Release Notes

Information for December 2025 Update

NXR-1000 Series

R2.5

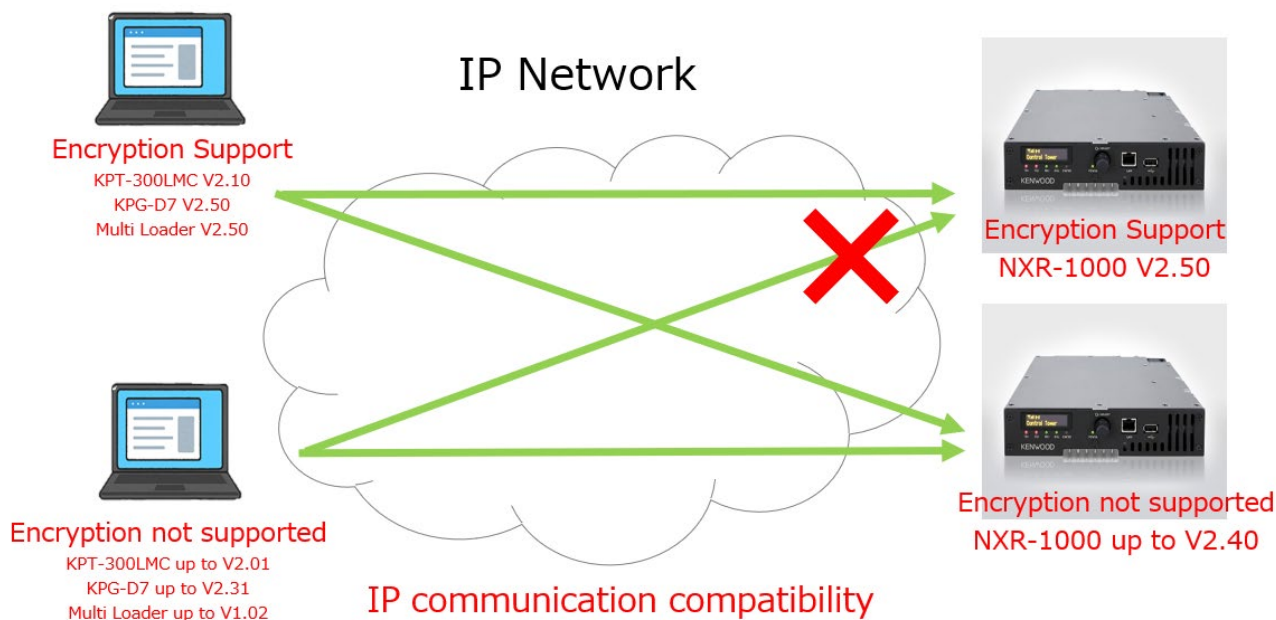
IP connection between the repeater and PC software is encrypted as shown below.

PC software that does not support encrypted IP communication cannot communicate with a repeater that uses encryption.

(OLED Menu) Control > Remote Access Control

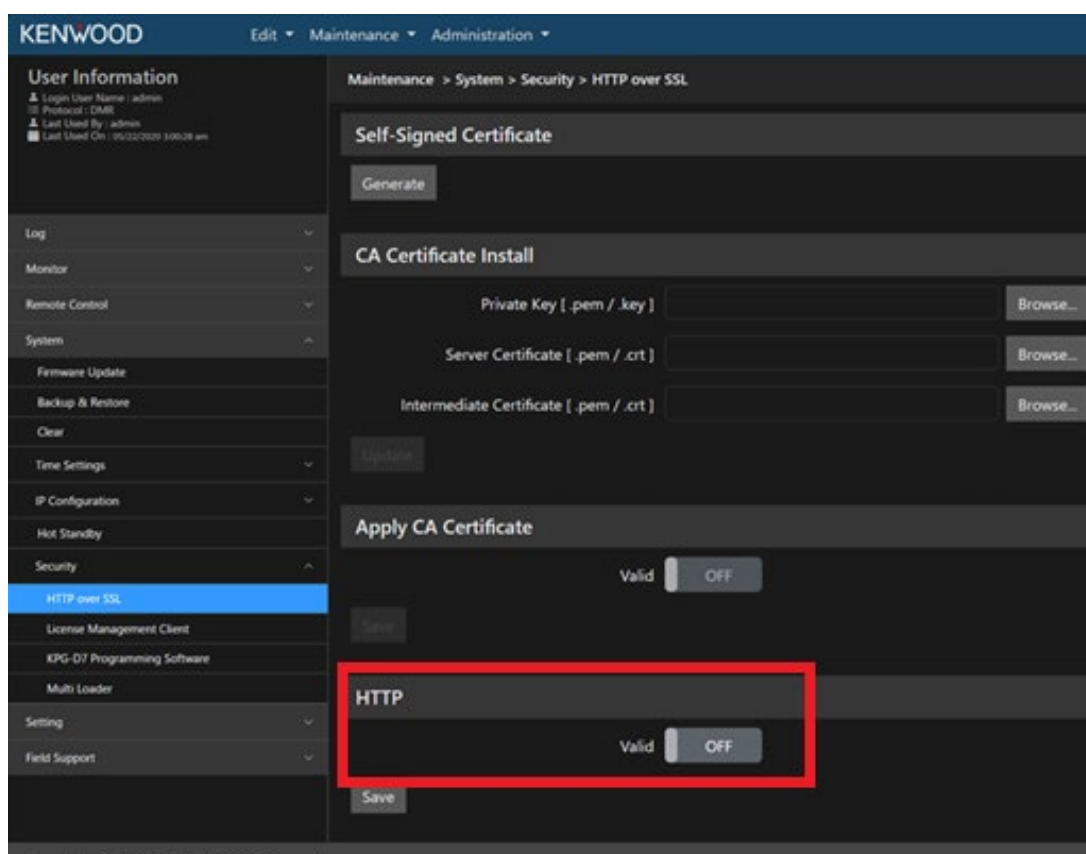
Starting with Firmware Version 2.50, Remote Access Control is turned OFF by default value when shipped from the factory or when Factory Reset is performed.

Therefore, when connecting to Web Tool for the first time and making settings, you must first enable Remote Access Control.

If you update a repeater with Remote Access Control already enabled (ON) to Version 2.50, the current settings will be retained.

1. Select "Control" from the OLED menu on the unit.
2. Select "Remote Access Control".
3. Change the setting from "Off" to "On".

3.1. KPT-300LMC

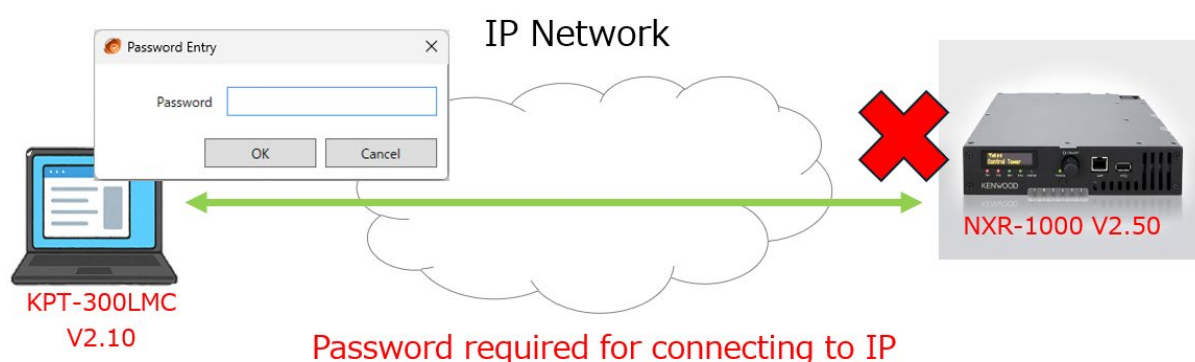
KPT-300LMC version is 2.10.

From this version, the password setting for IP connection is added.

< Password input/verification >

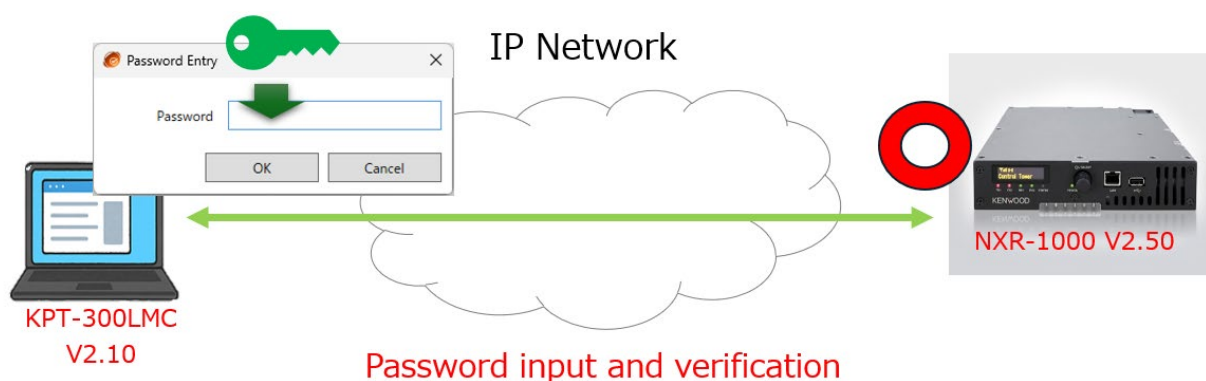
When the NXR-1000 Firmware V2.50 and KPT-300LMC V2.10 are connected via IP, the password request screen is displayed. This password is the same as the password for the KPT-300LMC previously set on the Web Tool.

KPT-300LMC can be used only when the correct password is entered.

KPT-300LMC cannot operate unless the correct password has been entered.

KPT-300LMC is enabled when it matches the password set in the repeater.

4.1. KPG-D7

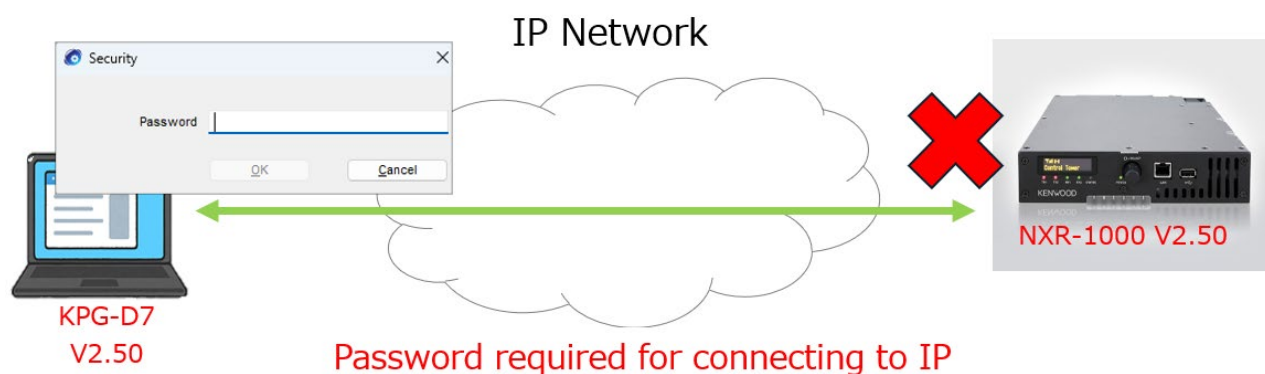
KPG-D7 version is 2.50.

From this version, the password setting for IP connection is added.

< Password input/verification >

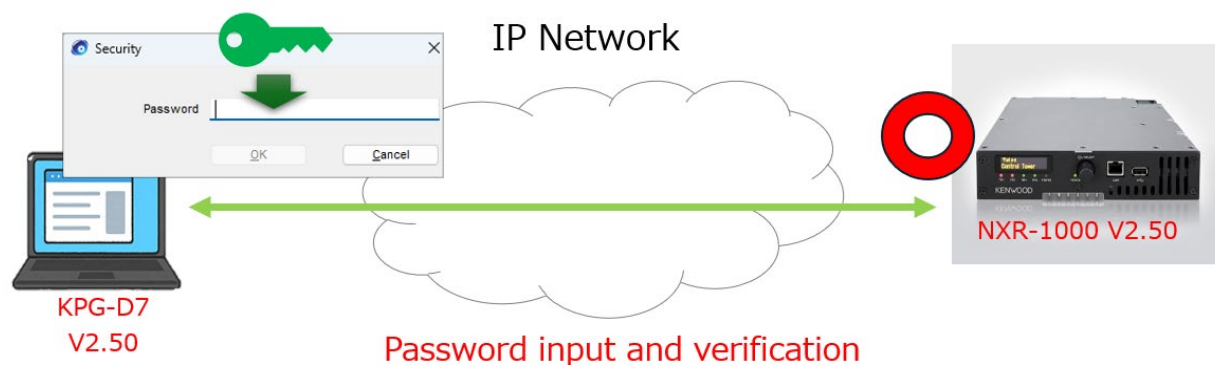
When the NXR-1000 Firmware V2.50 and KPG-D7 V2.50 are connected via IP, the password request screen is displayed. This password is the same as the password for the KPG-D7 previously set on the Web Tool.

KPG-D7 can be used only when the correct password is entered.

KPG-D7 cannot operate unless the correct password has been entered.

KPG-D7 is enabled when it matches the password set on the repeater.
